AMENDMENT - INVITATION TO TENDER

Title-Sujet: Construction – Building Renovations and Upgrades	
Solicitation No. - No. de l'invitation 201901010	Date July 13 th , 2018
Client Reference No. - No. De Référence du Client 201901010	Amend No.- No. du modif. 006
GETS Reference No. - No. de Référence de SEAG 201901010	
Solicitation Closes –L'invitation prend fin at - à 2 :00 EDT on - le July 18th, 2018	
F.O.B. - F.A.B. Destination	
Address Enquiries to: - Adresser toutes questions à: jordan.mckenna@rcmp-grc.gc.ca	
Telephone No. - No de telephone 613.843.5518	Fax No. - N° de FAX:
Destination of Goods, Services, and Construction: Destinations des biens, services et construction:	
Delivery Required - Livraison exigée:	Delivery Offered - Livraison proposée
Name and title of person authorized to sign on behalf of Vendor/Firm Nom et titre de la personne autorisée à signer au nom du fournisseur/de l'entrepreneur

ADDENDUM No. 1

Project Number: 7212283

2 NORTH/SOUTH BUILDING SECTION NEW (PARTIAL)
SCALE 1:50

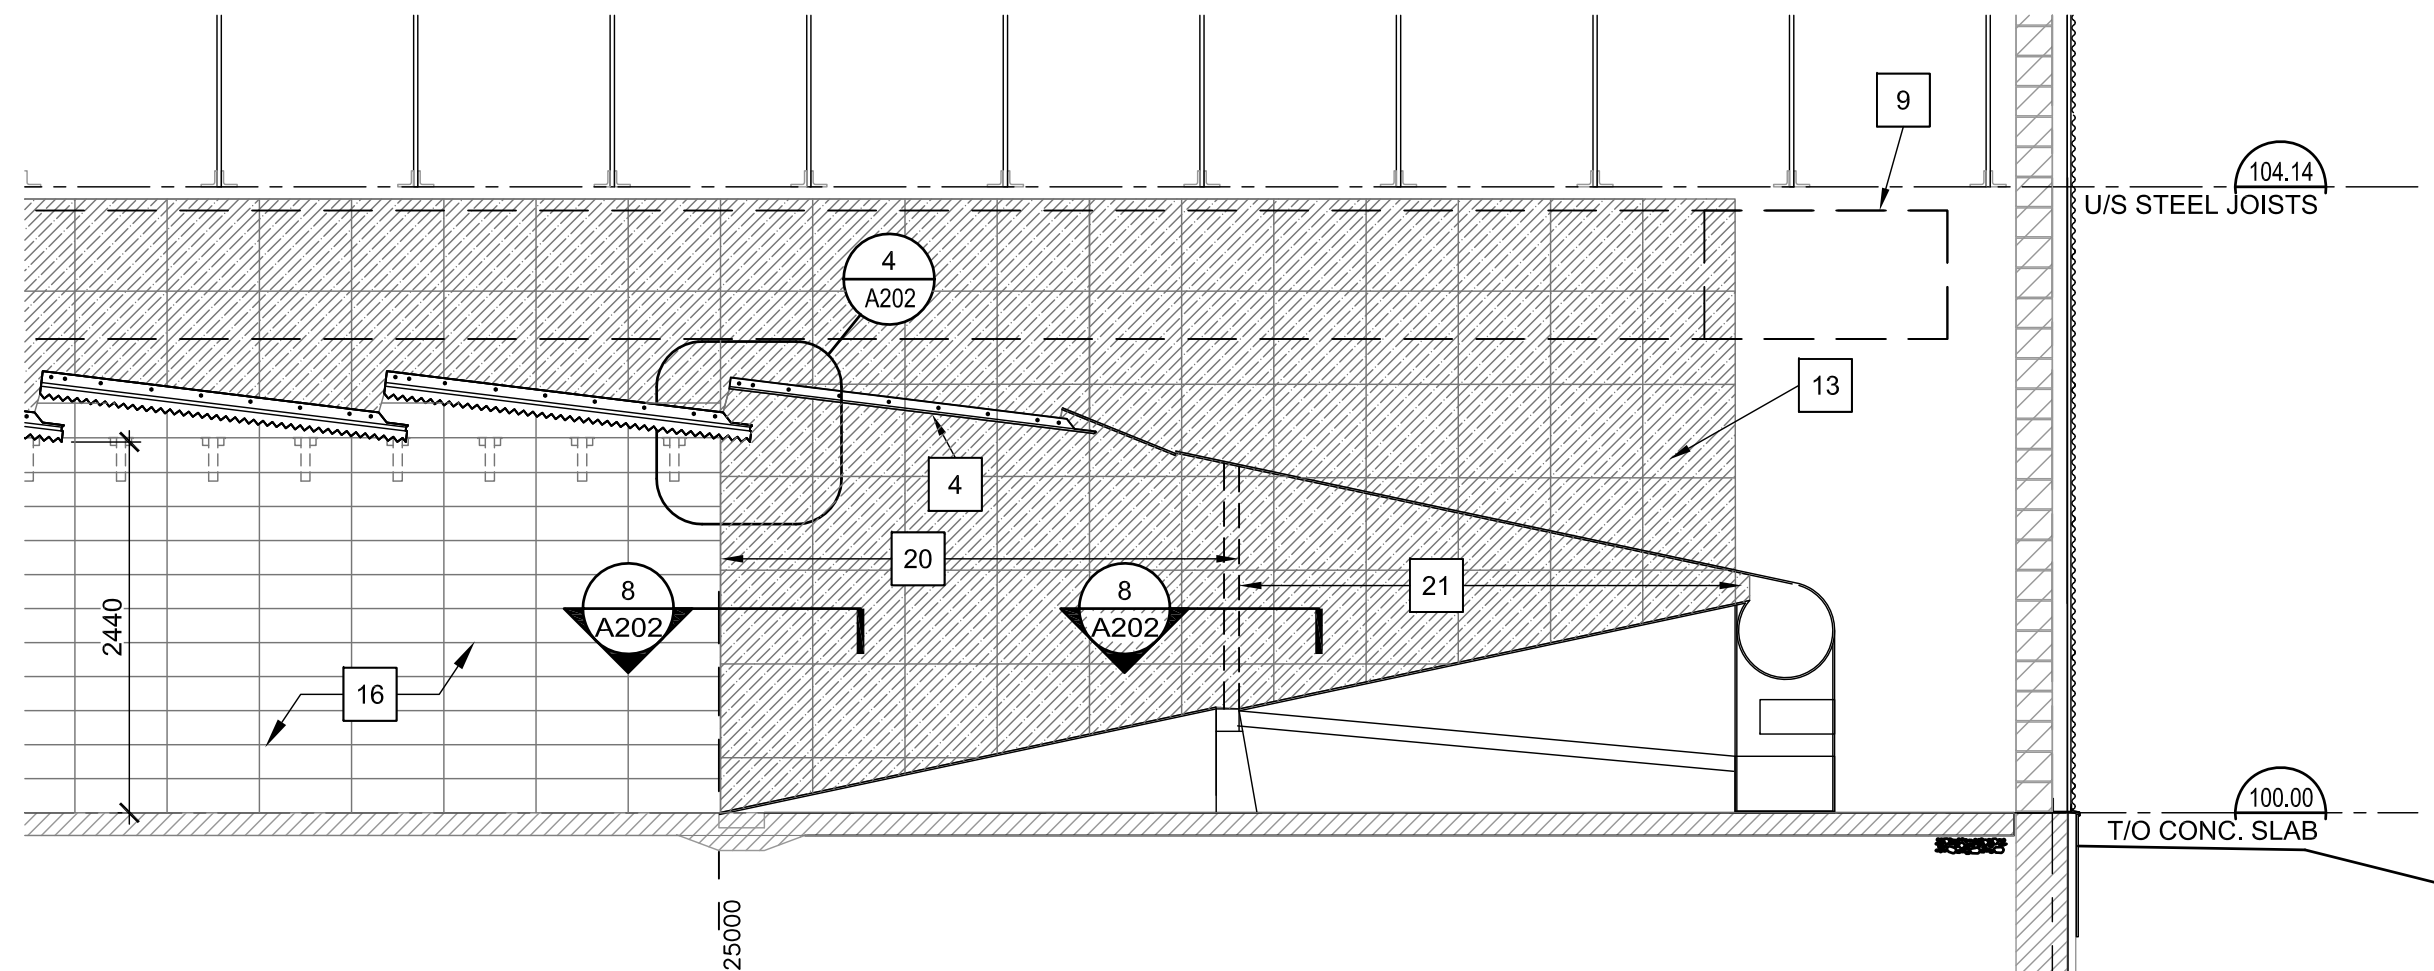
1. **A201 BUILDING SECTIONS**
 - .a Refer to Detail 2/A202 NORTH/SOUTH BUILDING SECTION. Revise as indicated in ADD1-SK1 attached.
 - .b Refer to DRAWING NOTES A201 and revise as indicated in ADD1-SK1 attached.
2. **A202 DETAILS**
 - .a **ADD** Detail 8/A202 as shown in ADD1-SK1 attached.
 - .b Refer to DRAWING NOTES A202 and revise as indicated in ADD1-SK1 attached.

DRAWING NOTES A201:
REVISED & SUPPLEMENTAL DWG. NOTES TO SHEET A/201

- 17. NOTE NOT USED.
- 20. -50mm BALLISTIC PANELS
-16Ga. VERTICAL FORMED CHANNEL TO CREATE AIRSPACE TO SUIT DEPTH OF OFFSET OF EXISTING BULLET TRAP SIDEWALL FROM CONCRETE BLOCK RANGE WALL. PROVIDE DOUBLE CHANNEL AT EACH JOINT AND AT MIDPOINTS OF PANELS.
-10mm AR500 STEEL PLATES ATTACHED TO EXISTING STEEL PLATE WALL FINISH
- 21. -50mm ACOUSTIC BALLISTIC PANELS
-10mm AR500 STEEL PLATES ATTACHED TO EXISTING STEEL PLATE WALL FINISH
